Beaver Valley Power Station, Unit Nos. 1 and 2

License Amendment Request to Modify Technical Specifications 3.4.16, "RCS Specific Activity," 3.7.13 "Secondary Specific Activity," 5.5.7, "Ventilation Filter Testing Program (VFTP)," and 5.5.14, "Control Room Envelope Habitability Program"

Subject: Application to Revise Technical Specifications 3.4.16, "RCS Specific Activity," 3.7.13 "Secondary Specific Activity," 5.5.7, "Ventilation Filter Testing Program (VFTP)," and 5.5.14, "Control Room Envelope Habitability Program"

Figure 3.4.16-1 (Page 1 of 1)
Reactor Coolant DOSE EQUIVALENT I-131 Specific Activity
Limit Versus Percent of RATED THERMAL POWER (Unit 1)

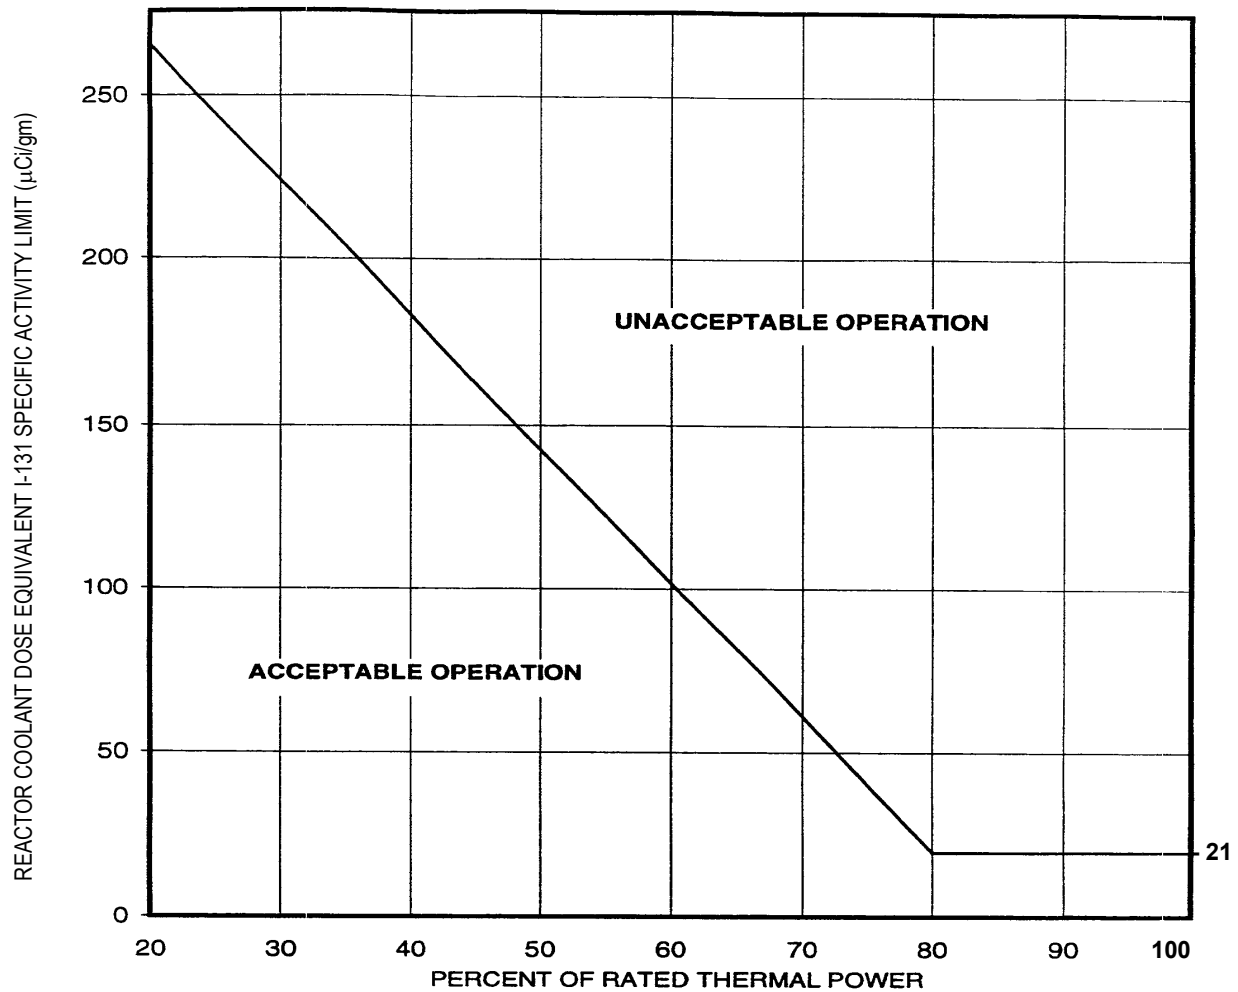
Figure 3.4.16-1 would have an administrative change to add "(Unit 1)" at the end of the figure title.

Figure 3.4.16-2 (Page 1 of 1)
Reactor Coolant DOSE EQUIVALENT I-131 Specific Activity
Limit Versus Percent of RATED THERMAL POWER (Unit 2)

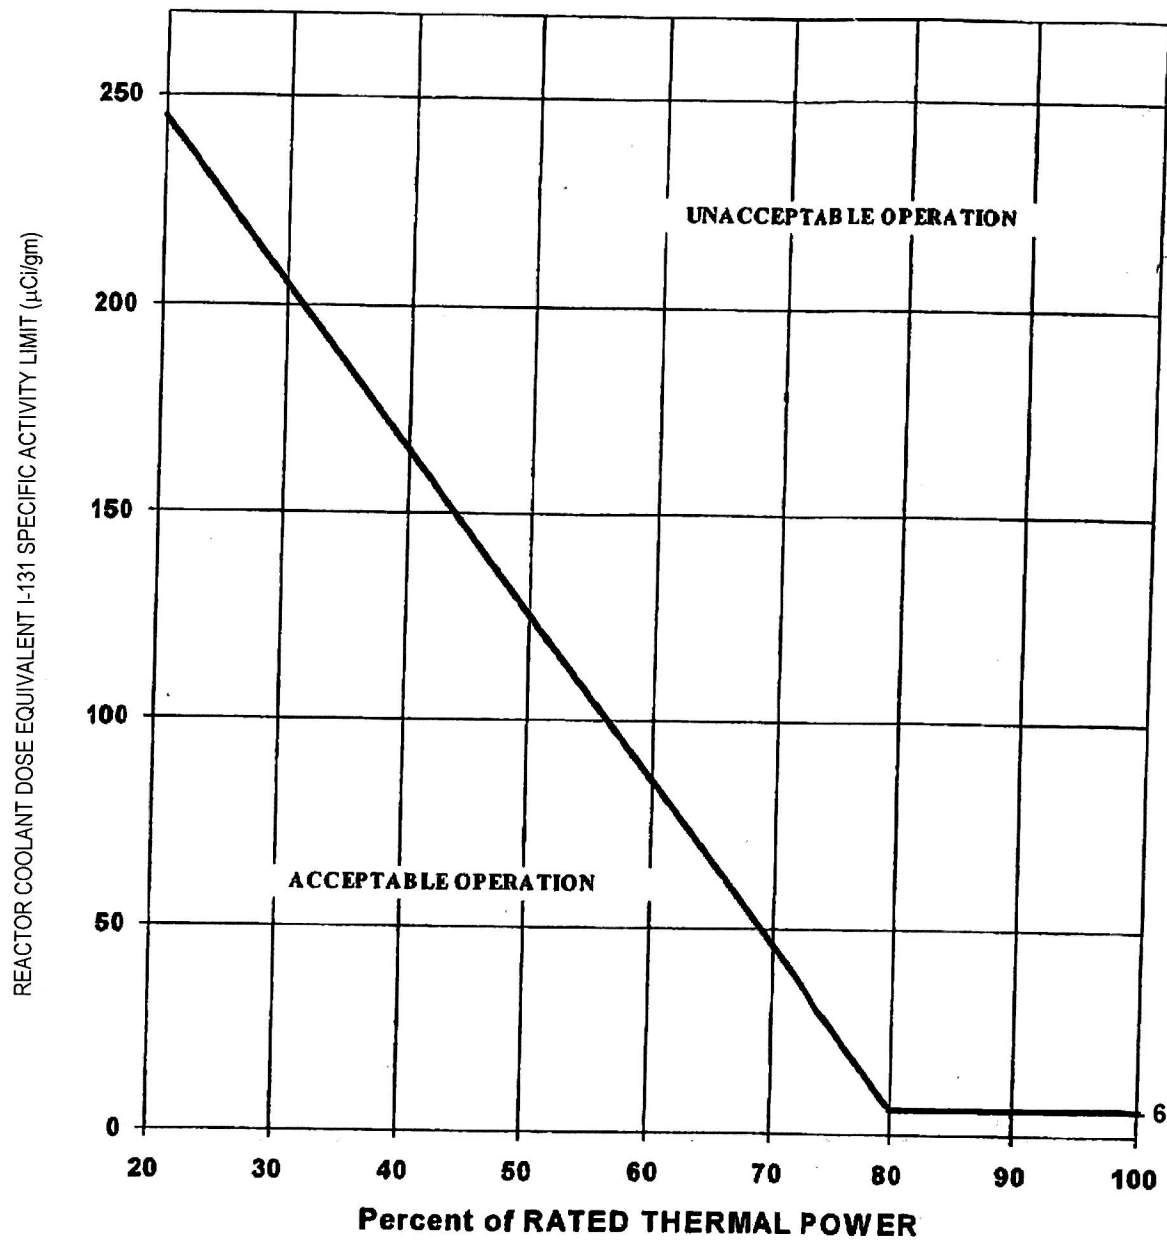
A new Figure 3.4.16-2 is added for the BVPS-2 specific activity limit versus percent of rated thermal power.
